COUNTY OF SAN MATEO
Inter-Departmental Correspondence

TO: Honorable Board of Supervisors
FROM: Brian Zamora, Director, Public Health and Environmental Protection Division
SUBJECT: APPEAL OF THE ENVIRONMENTAL HEALTH DIRECTOR'S DENIAL OF A PERMIT TO
INSTALL A SEPTIC SYSTEM FOR A PARCEL LOCATED ON SKYLINE BOULEVARD
(APN 067-222-280)

**SEWAGE DISPOSAL SYSTEM
PLOT PLAN**

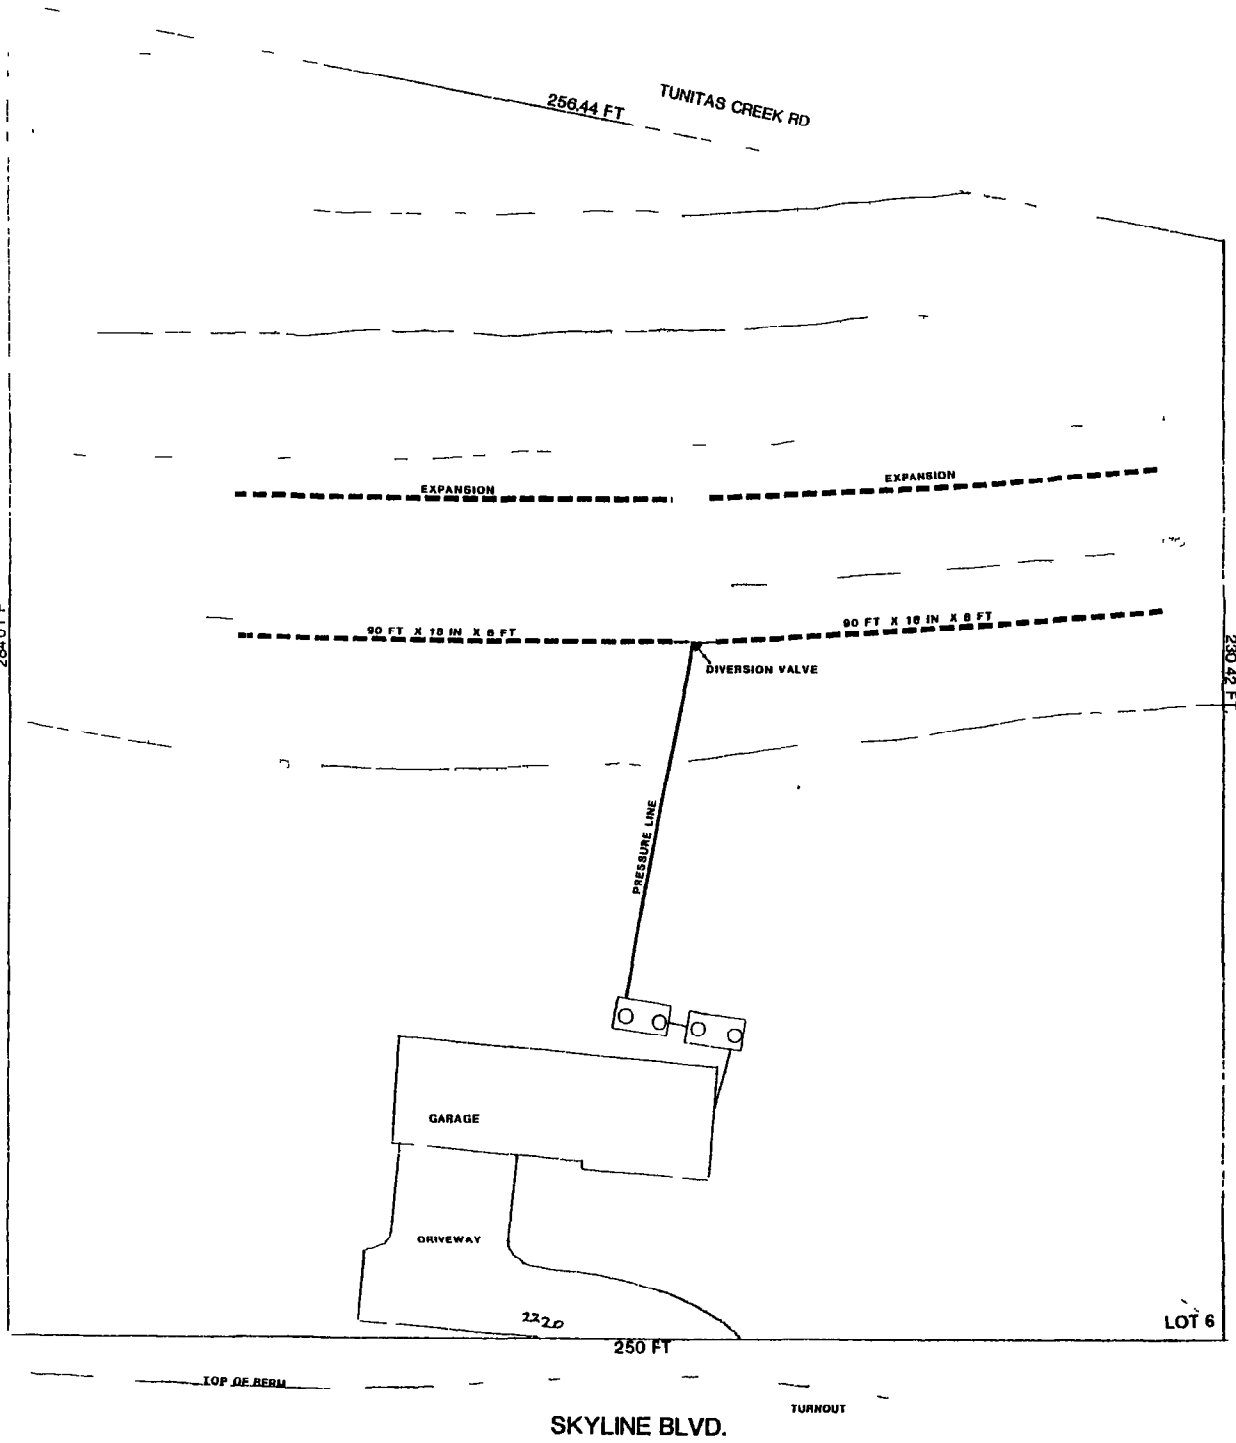
The permit application is deficient, as it is not in compliance with Section 9321 and Section 9325 of the Ordinance. Section 9325 prohibits both the installation of a drainfield within 50 feet of a slope of 50% or greater, and the issuance of an exception to this setback. In addition, Section 9325 requires a minimum of six percolation test holes per building site, only two were completed in 1990.

On August 9, 2000, the appellant was informed that the septic system plans submitted were not acceptable based on the new slope requirements. Field observations indicate that the entire property exceeds a 50% slope, and therefore the appellant was asked to supply a site plan showing detailed contours lines with labeled elevations, and to perform the additional percolation testing.

- 4 The applicant was requested to perform more percolation testing, and to demonstrate that the proposed drainfields were not within 50 feet of a slope equal to or exceeding 50%.

Deny the appeal and uphold the decision of the Director of Environmental Health to deny a septic system permit under the Individual Onsite Wastewater Treatment and Disposal Systems Ordinance (Ordinance)
